**LOUISIANA
POWER & LIGHT**

December 23, 1983

W3P83-4180
3-A1.01.04
3-A1.10
Q-3-N21

SUBJECT: Waterford SES Unit Number 3
Docket Number 50-382
Emergency Feedwater (EFW) Control System

FIGURES 7.3-8
7.3-10

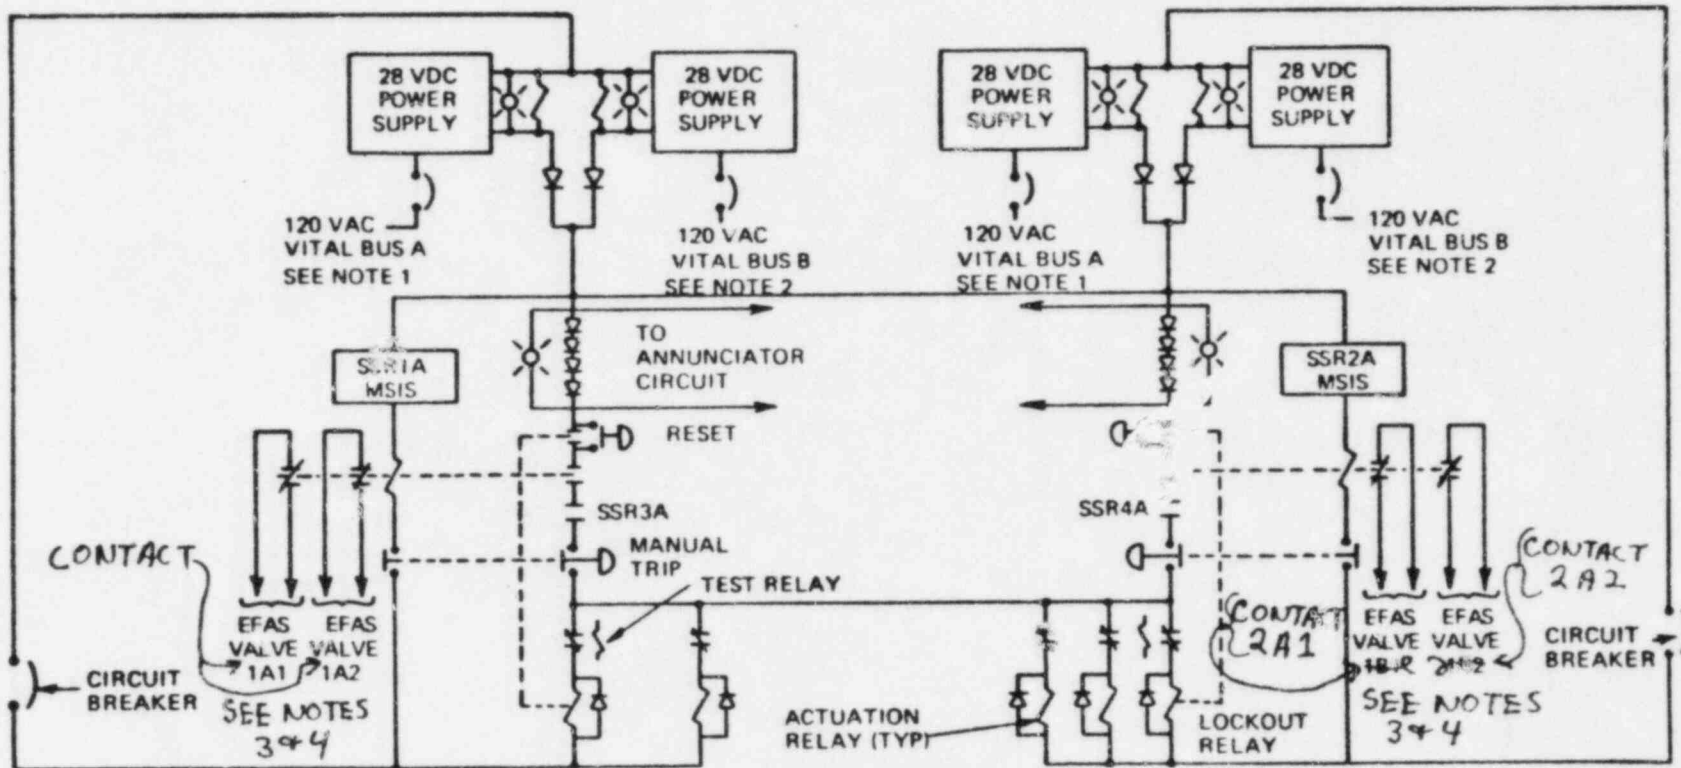
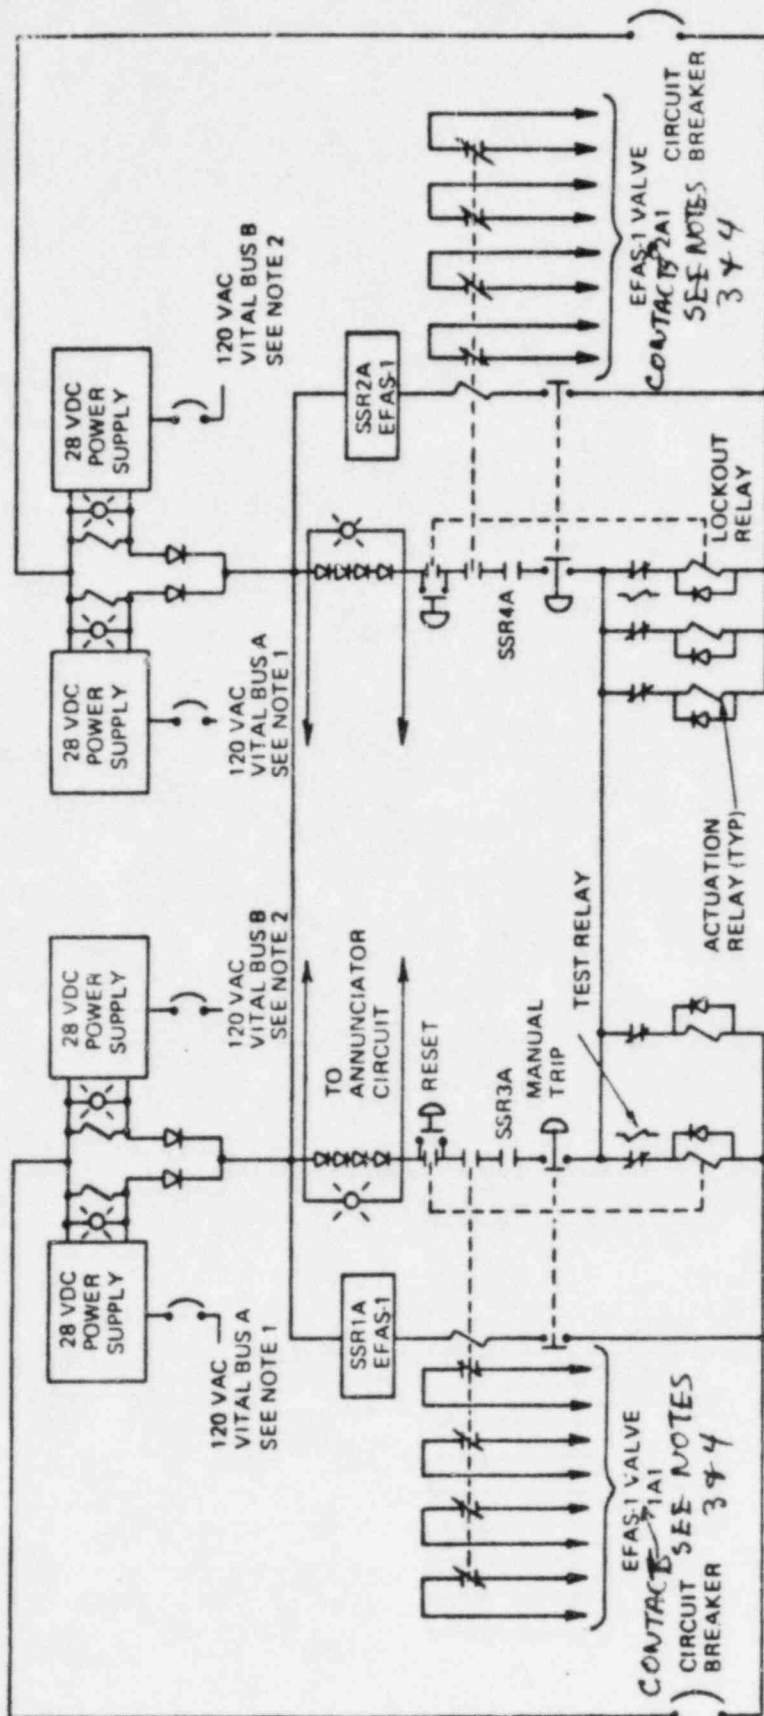
Item (1) involves amending the FSAR to clarify EFAS operation and/or logic. Attachment One indicates those FSAR revisions which have been proposed to address this item. These revisions will be included in Amendment 34 to the Waterford 3 SES FSAR.

- NOTES:
1. FOR CABINET 'B', SUBSTITUTE "VITAL BUS C" FOR "VITAL BUS A"
 2. FOR CABINET 'B', SUBSTITUTE "VITAL BUS D" FOR "VITAL BUS B"

3. VALVE CONTACTS 1A1 and 1A2 are for both shut-off valves in Train A and VALVE CONTACTS 2A1 and 2A2 are for both control valves in Train A

4. FOR CABINET 'B', SUBSTITUTE "3B1", "3B2", "4B1" and "4B2" for "1A1", "1A2", "2A1" and "2A2" respectively

NOTES: 1. FOR CABINET 'B', SUBSTITUTE "VITAL BUS C" FOR "VITAL BUS A"

2. FOR CABINET 'B', SUBSTITUTE "VITAL BUS D" FOR "VITAL BUS B"

3. VALVE CONTACTS 1A1 are for the shut-off valve in Train A and VALVE CONTACTS 2A1 are for the control valve in Train A
4. FOR CABINET 'B', SUBSTITUTE "3B1" and "4B1" for "1A1" and "2A1" respectively

REVISION TO LOU-1564-B424

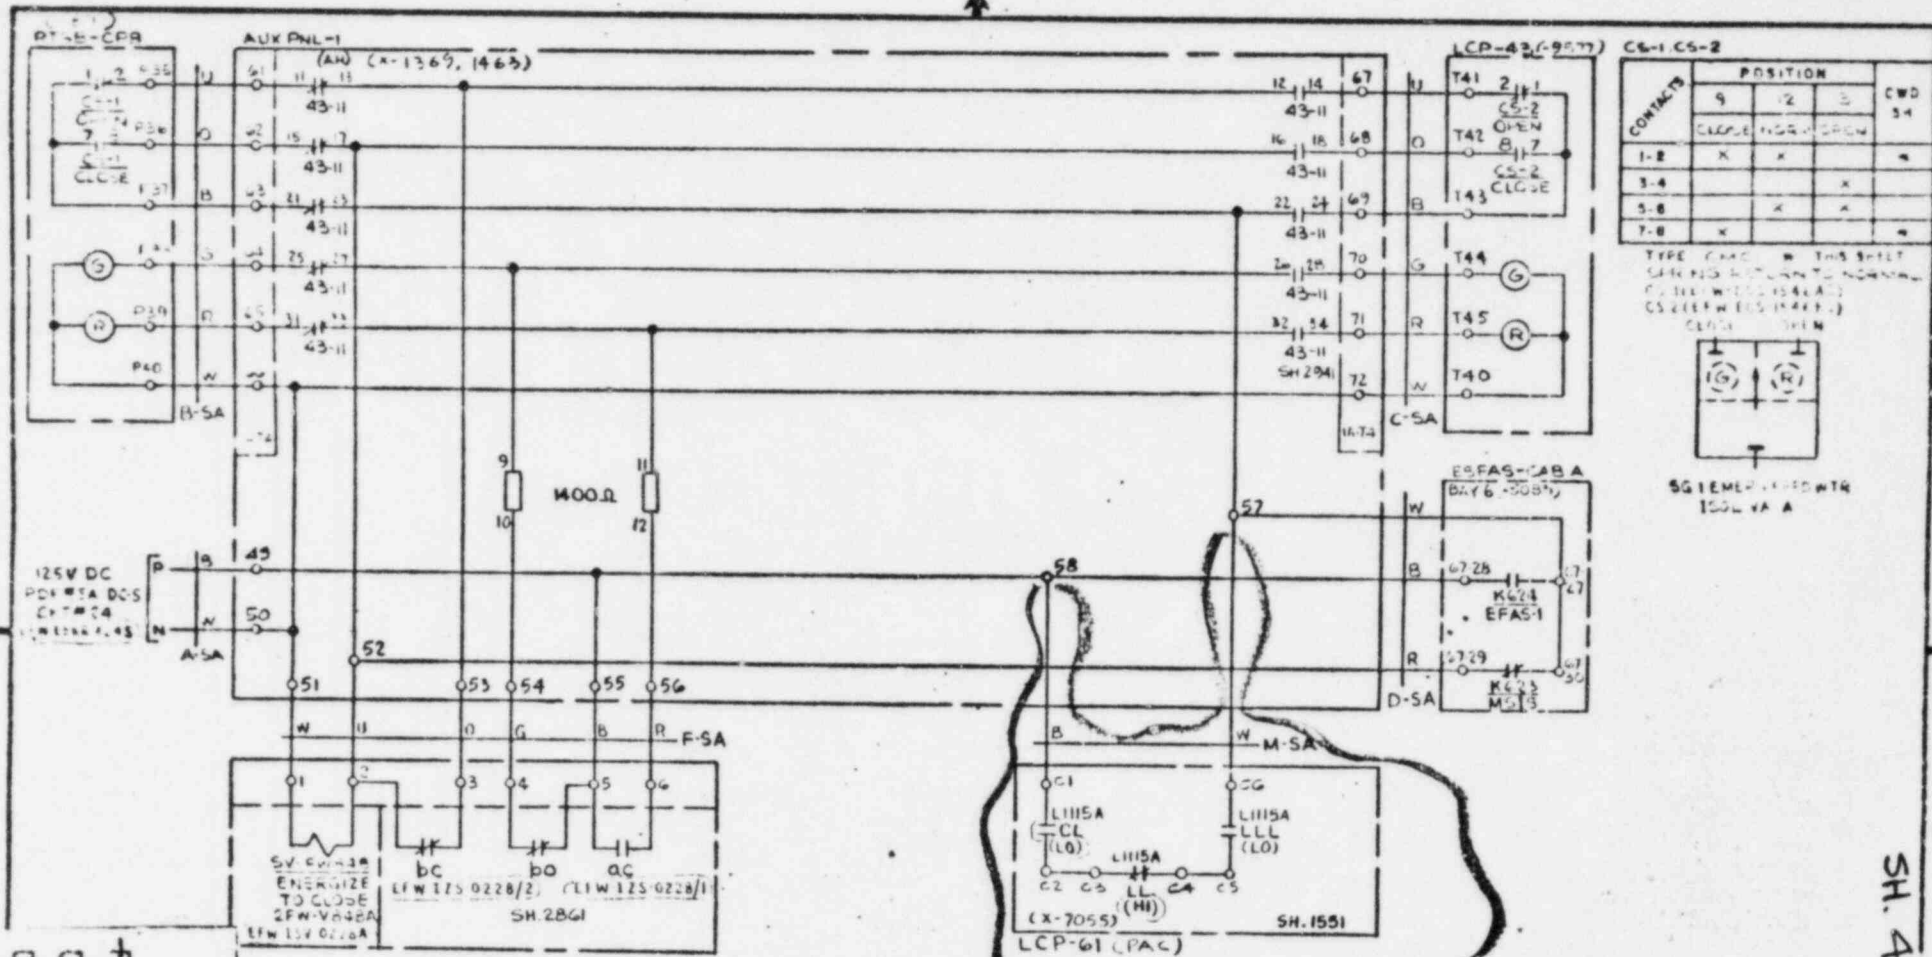
Item (3) requires that LP&L evaluate and overcome the postulated event where the single failure of a steam generator level transmitter can inhibit the automatic initiation of EFW flow to an intact steam generator. This event is possible because both "A" channel valves or both "B" channel valves are controlled by a single "A" or "B" level transmitter for a particular steam generator. This postulated event can be overcome by removing the level contacts to the shut-off valves of both "A" and "B" trains for each steam generator at the PAC panels. This results in these shut-off valves being opened by an EFAS signal rather than simply being released to the control of the level transmitter. Since there is no longer a contact between a particular level transmitter and its associated shut-off valve, the failure of any one level transmitter can at most disable only one control valve. Therefore, under this configuration, the failure of a single level transmitter will no longer inhibit either automatic or manual initiation of EFW flow. This configuration is shown in detail for Channel "A" of Steam Generator No. 1 by Attachment Two.

REMOVAL OF LEVEL CONTACTS FOR
STEAM GENERATOR 1, CHANNEL "A"
SHUT-OFF VALVE AT PAC PANEL

DELETE

FIGURE 8.17

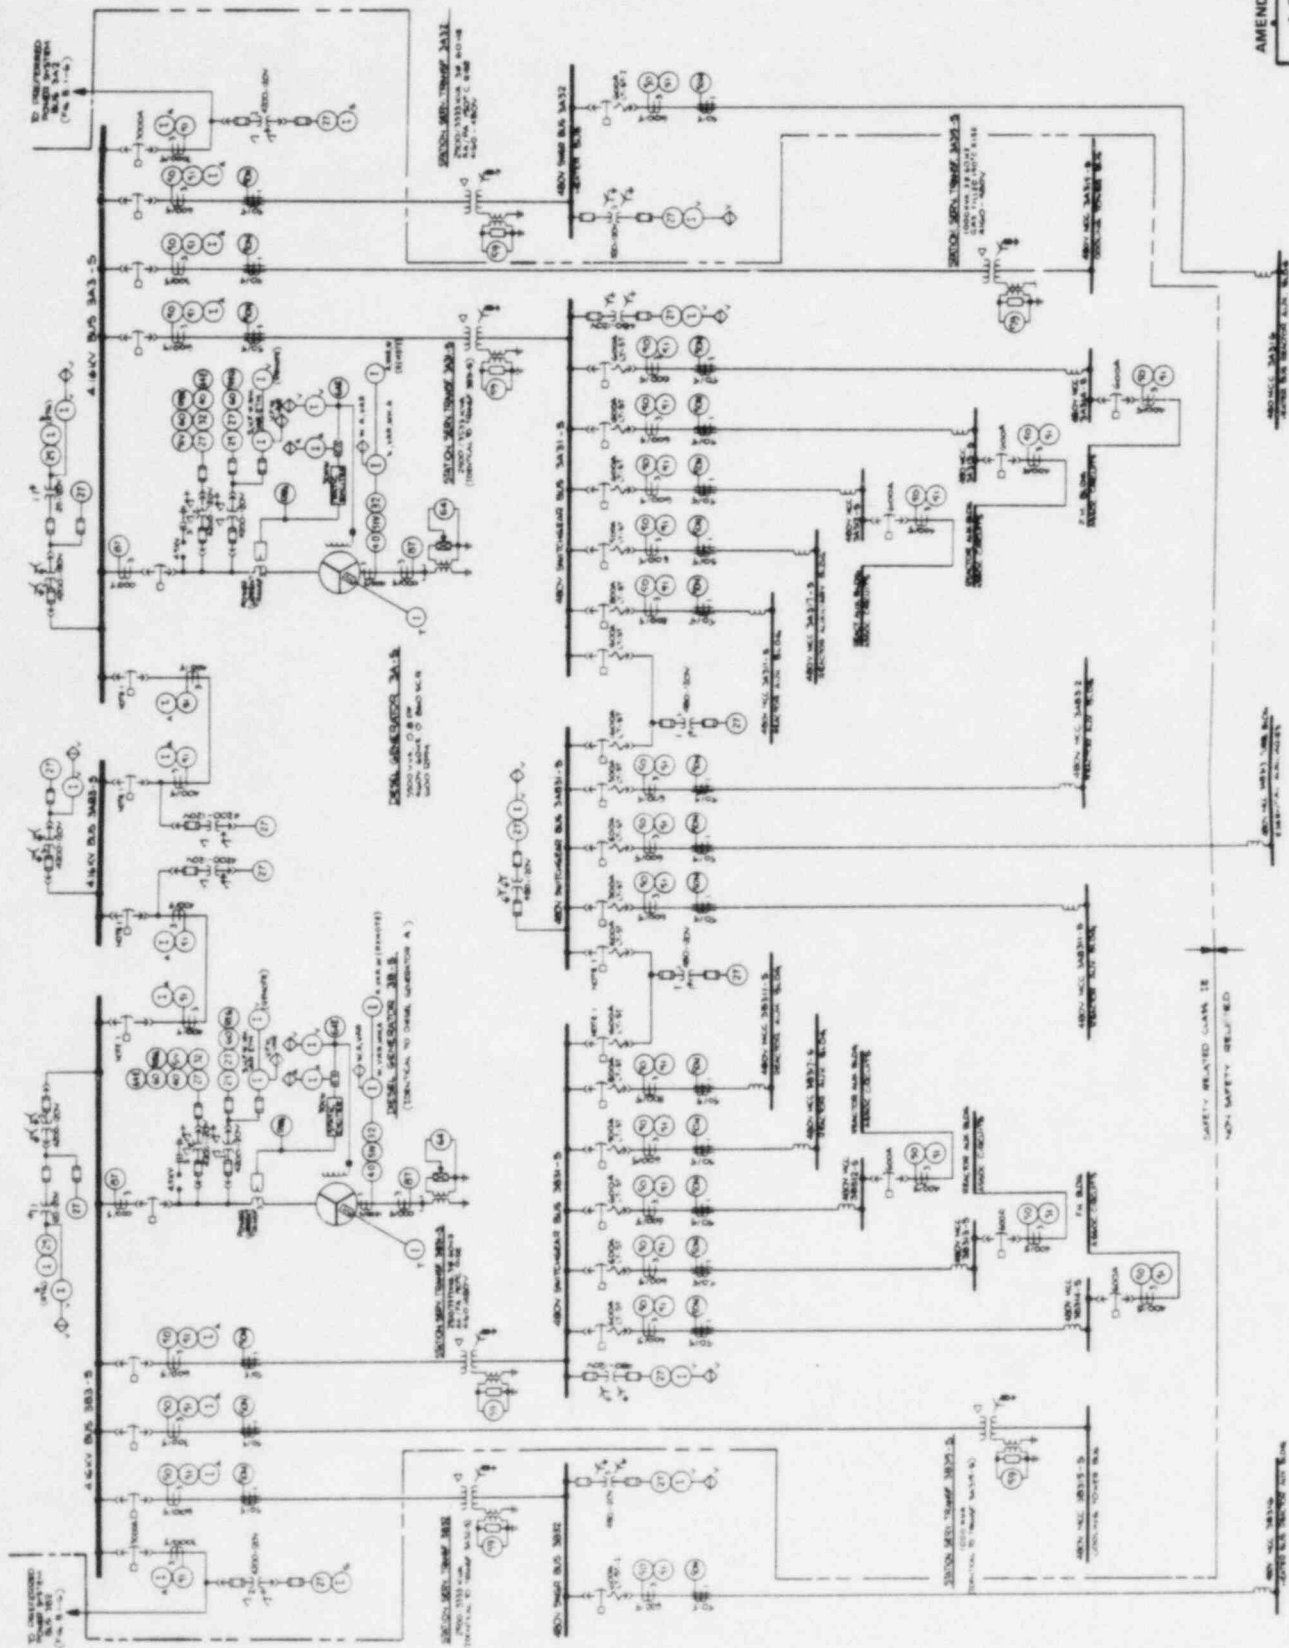
Item (6) requests that LP&L evaluate the effect of an overcurrent condition on the D.C. power trains which operate the EFW valves. The results of this evaluation indicate that a failure of the D.C. power supply to a channel will fail that channel, but will neither block nor establish EFW flow. Protective devices are provided to guard against such an overcurrent condition. Should an overcurrent occur, these protective devices will cause failure of that power train which will in turn cause both valves operated by this train to fail open. Under this condition control is still maintained by the redundant channel. Furthermore, there is no postulated single failure of the D.C. power supply which causes both channels of EFW to fail; either to actuate or to fail to actuate. These conclusions are supported by FSAR Figures 8.1-7 and 8.1-8 as shown in Attachment Four.
